**NUMBER:** 23-039-11

Door Smart Glass Self Cycling And/Or Battery Drain

2011                      (LC)                                      Challenger

**Fig. 1 Verify Latch Build Date (Julian Date)**

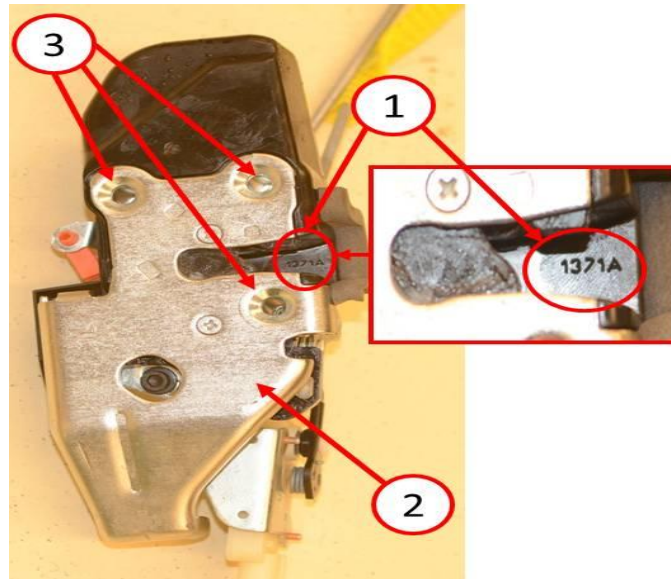
If the customer is experiencing this condition, check the door latch build date (1) as shown in the graphic for both Right and Left doors (Fig. 1).

- 
1. Does either of the door latch build dates fall between Julian date 3200 (Nov 20th 2010) and 0841 (March 25th 2011) ?
    - a. Yes >>> proceed to the Repair Procedure and replace the faulty latch and/or latches.
    - b. No >>> further diagnosis is required, this bulletin does not apply.

1. Replace the faulty door latch and/or latches. Refer to the detailed procedures available in DealerConnect>TechCONNECT> under: Service Info> 23-Body> Door - Front> LATCH, Door> Removal/Installation.
